ADDENDUM #1

PROJECT NAME: SCCAD Headquarters

CLIENT NAME: St. Charles County Ambulance District

PROJECT NO.: 18007

Sheet No.
S302

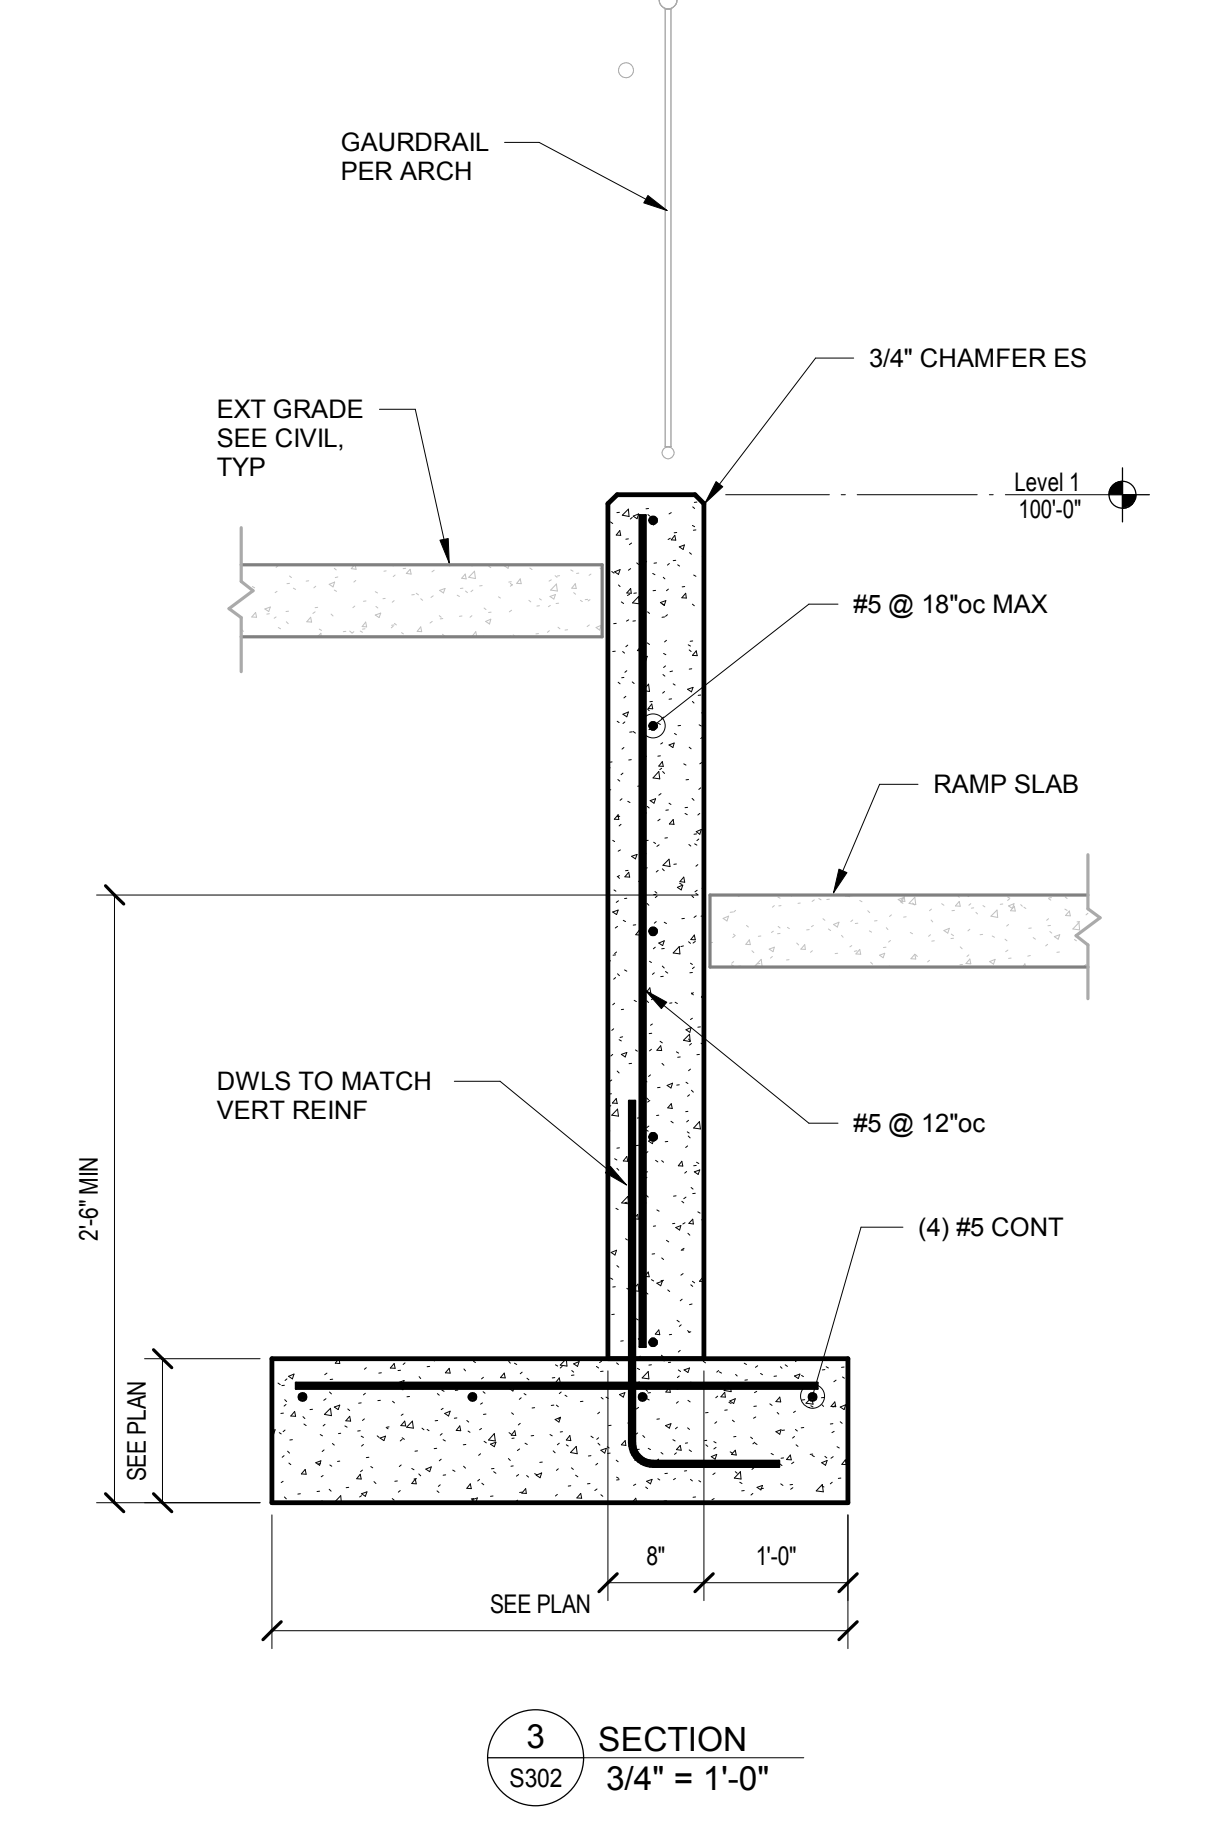
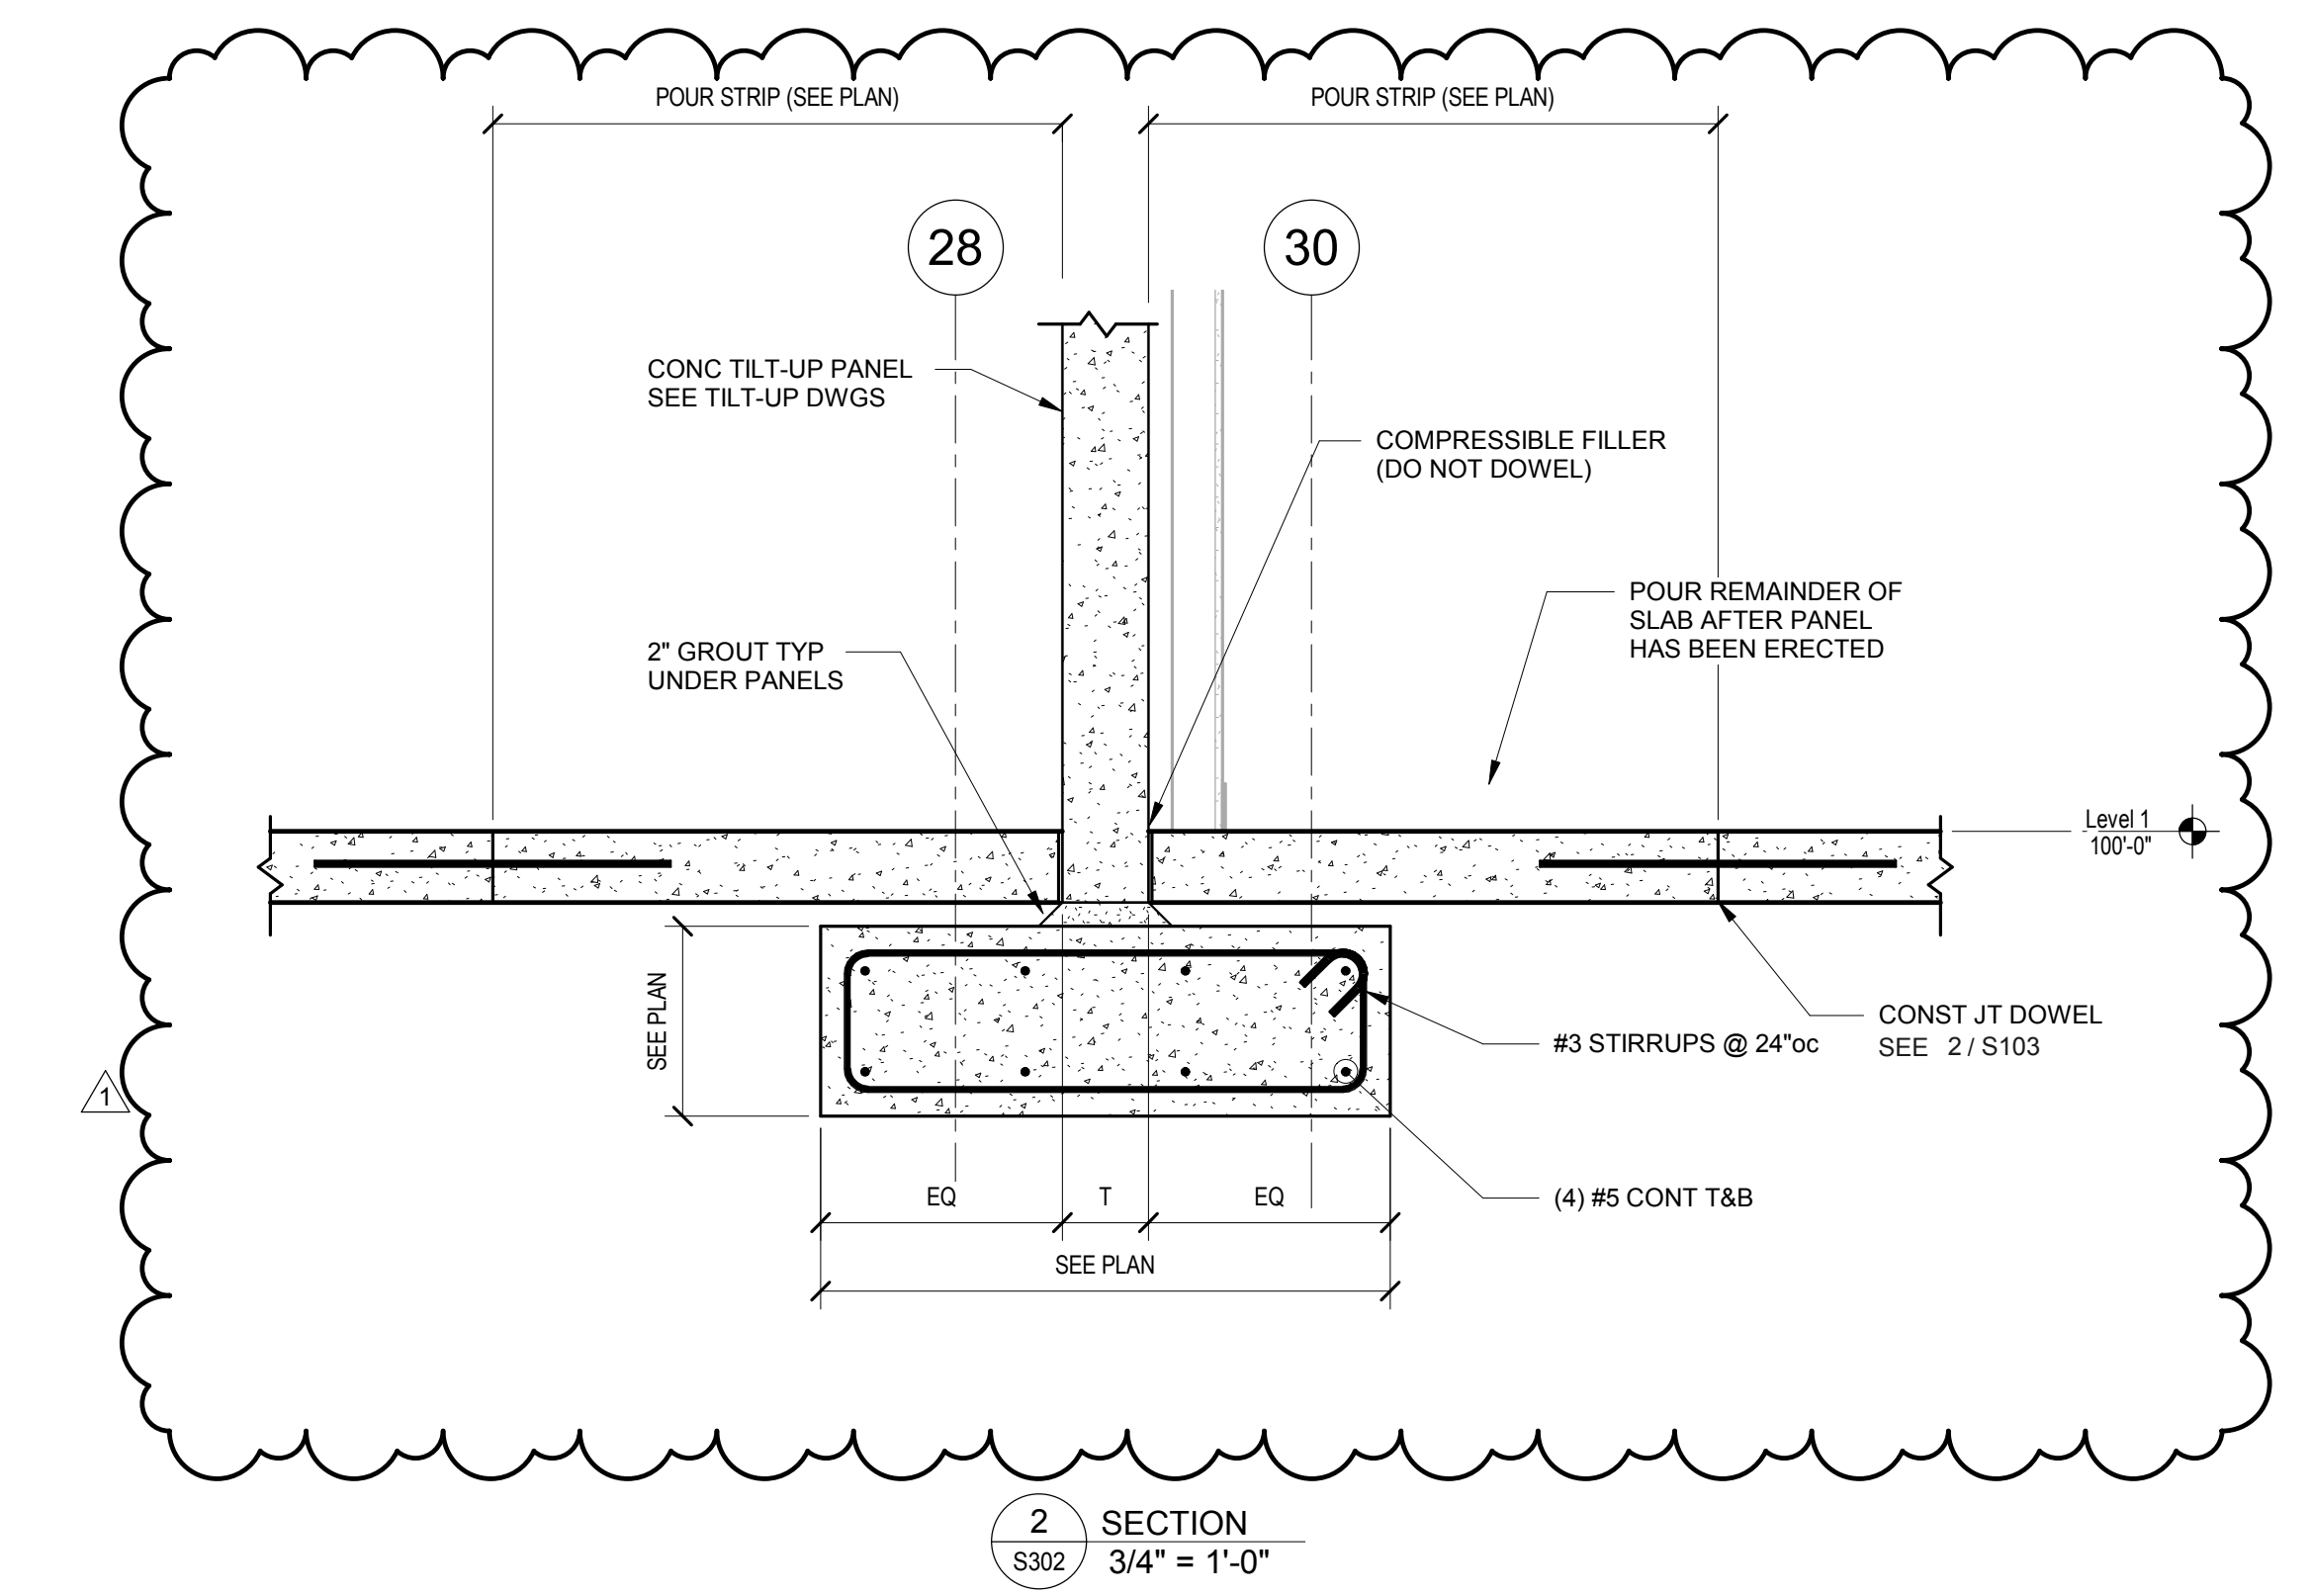
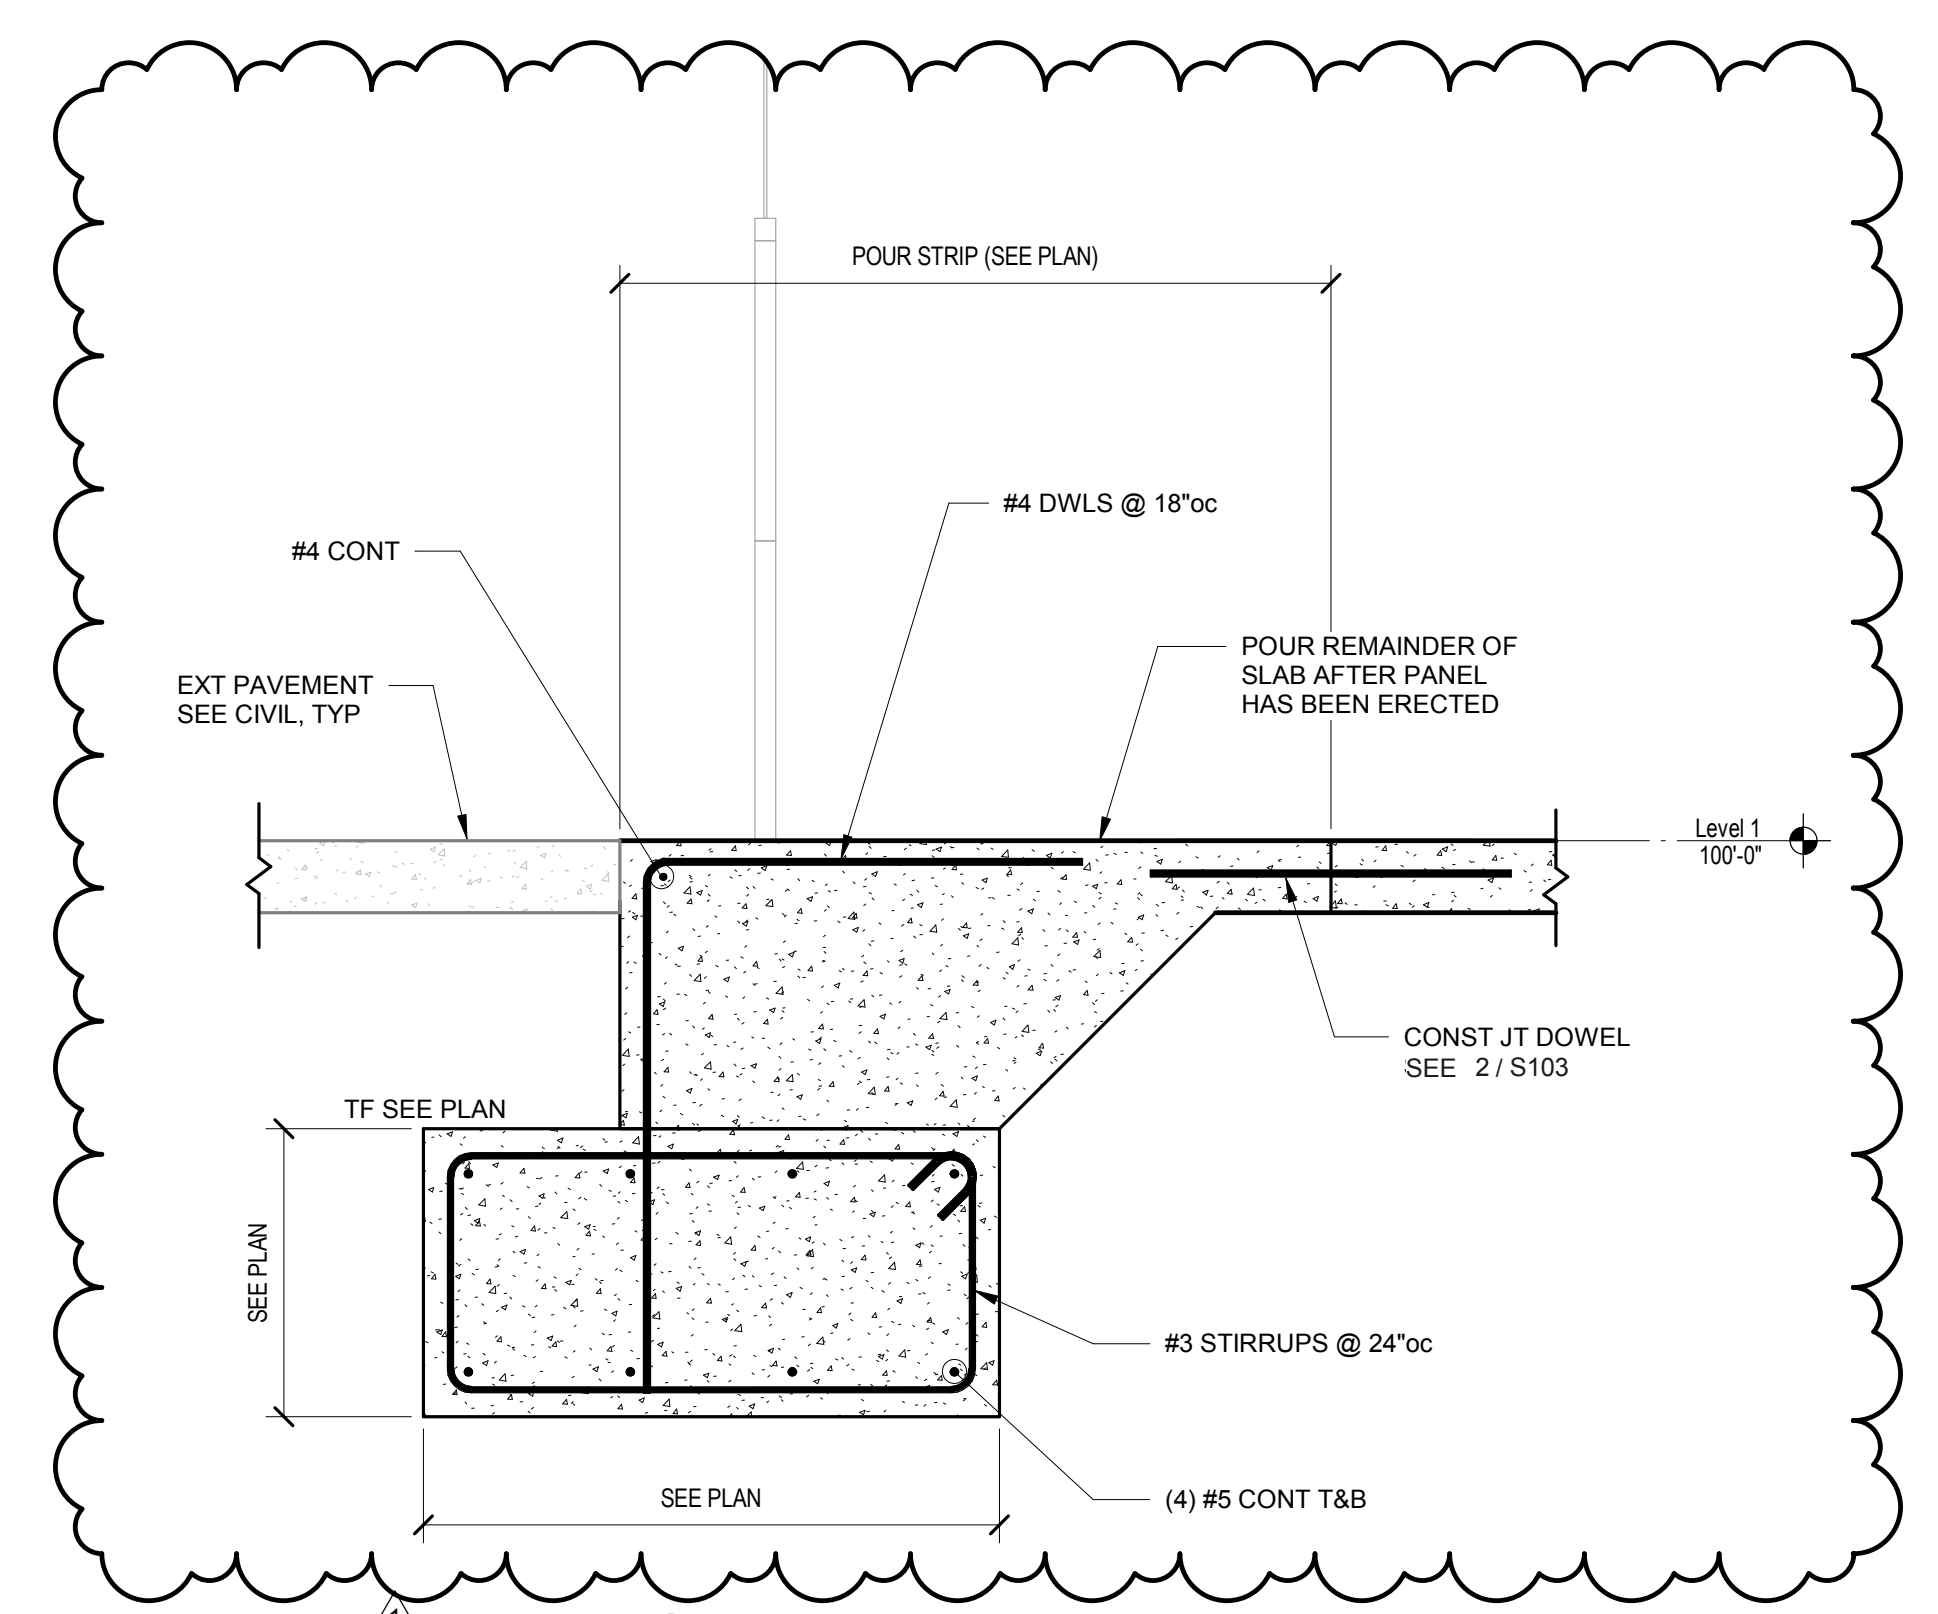
Sheet S302

- 1/S302 – Filled in detail information
- 2/S302 – Filled in detail information
